Contract #: 04-0120F4Cty: SF/ALA Rte: 80 PM: 13.2/13.9File #: 69.25B**QUALITY ASSURANCE -- NON-CONFORMANCE REPORT****Location:** Changxing Island, Shanghai, P.R. China**Report No:** NCR-000761**Prime Contractor:** American Bridge/Fluor Enterprises, a JV**Date:** 10-Jun-2010**Submitting Contractor:** Zhenhua Port Machinery Company, Ltd (ZPMC), Changxing Island**NCR #:** ZPMC-0723**Type of problem:**

**Reference Description:** Repair Procedure not following WPS**Description of Non-Conformance:**

**Subject:** NCR No. ZPMC-0723

**Reference Description:** Repair Procedure not following WPS/Tower/ Base Shear Plate A25

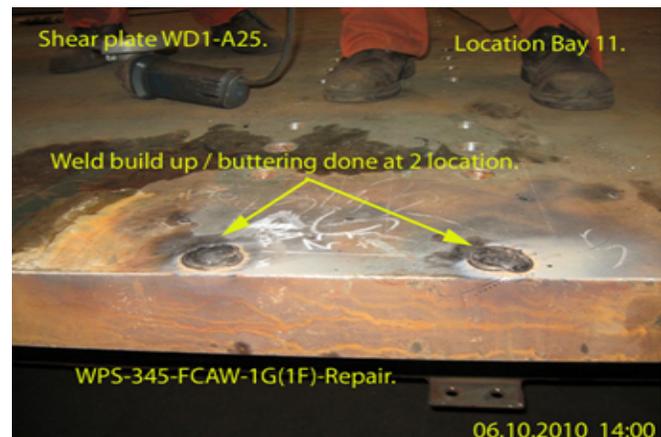
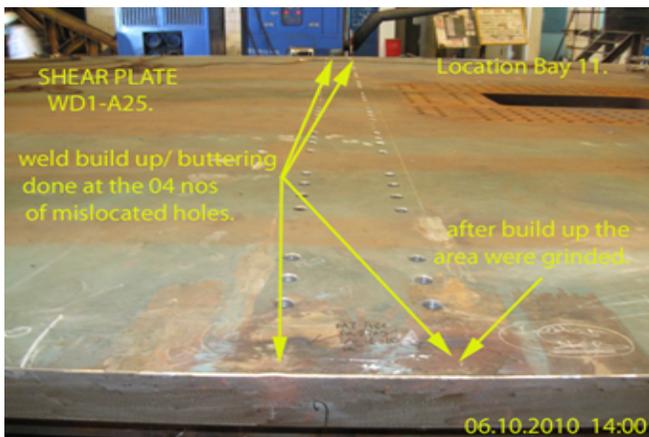
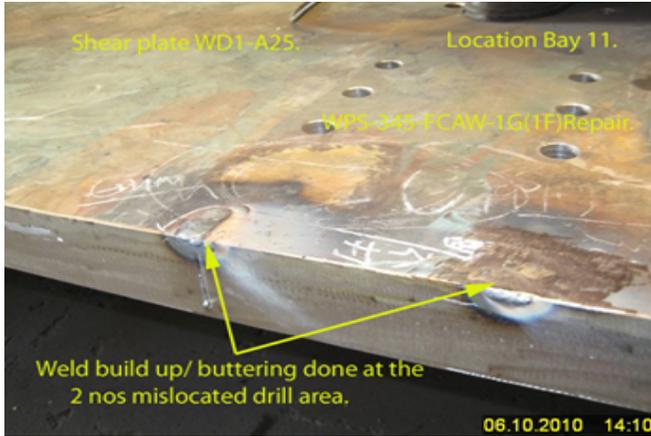
- During random visual inspection in Bay 11, this Quality Assurance Inspector discovered the following issues:
- ZPMC personnel performing Flux Core Arc Welding for base metal repair on mislocated holes on the surface of shear plate WD1-A25.
- ZPMC Quality Control (QC) presented WPS-345-FCAW-1G (1F)-Repair as applicable to repair.
- The repair welding completed without elongating the holes drill area as required by applicable WPS.
- This repair welding performed in the similar manner on four (4) holes of shear plate WD1-A25.
- Shear plate identified as WD1-A25.
- The members are located in Bay #11.

For further information, please see the attached pictures below.

**Reference Resolution:** ZPMC has repaired the base metal in accordance with the attached WPS and is providing the MT and UT to show that it is acceptable.

The material in question is actually TTP and not TM/SRM. ZPMC has repaired the base metal in accordance with the attached WPS and is providing the MT and UT to show that it is acceptable. Based on this ZPMC requests closure of this NCR.

The proposed resolution is accepted with action pending. The MT and UT results are acceptable; however, ZPMC did not address the apparent failure of Quality Control to identify the non-conformance with the appropriate Welding Procedure Specification (WPS). This NCR will be considered closed once the documentation of the steps taken by the Quality Control Manager to prevent future occurrences is submitted and reviewed.

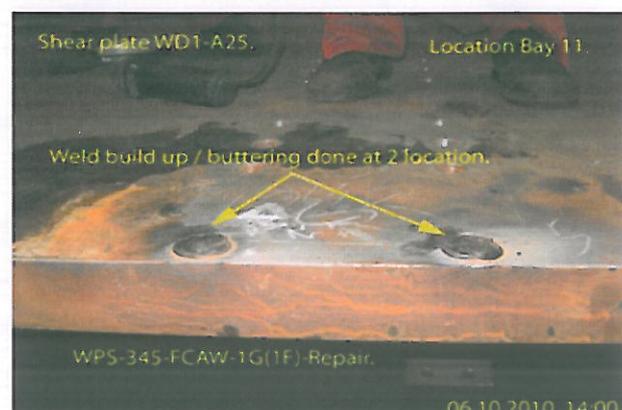
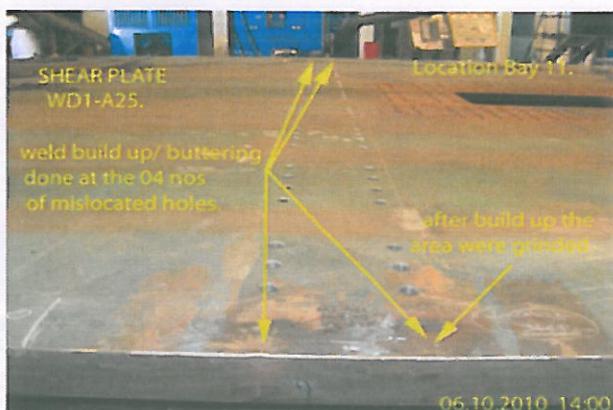
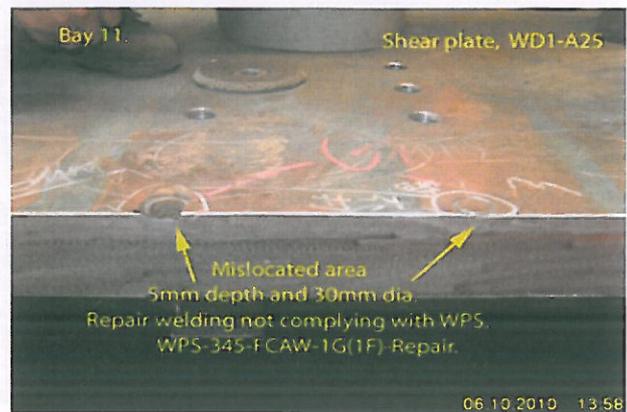
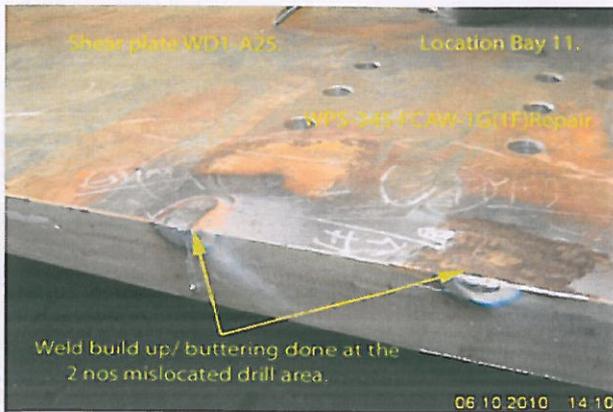
- ZPMC personnel performing Flux Core Arc Welding for base metal repair on mislocated holes on the surface of shear plate WD1-A25.

- ZPMC Quality Control (QC) presented WPS-345-FCAW-1G (1F)-Repair as applicable to repair.

- The repair welding completed without elongating the holes drill area as required by applicable WPS.

- This repair welding performed in the similar manner on four (4) holes of shear plate WD1-A25.

For further information, please see the attached pictures below.

Repair Base Metal per approved WPS and perform MT and UT of required areas.

ZPMC has repaired the base metal, and received with the approved WPS. NDT documentation included 100% MT and UT. Verifying repaired welds are now in conformance with contract requirements. In addition, QCM held a meeting with ZPMC's QA Department to review this type of incident to prevent future occurrences.
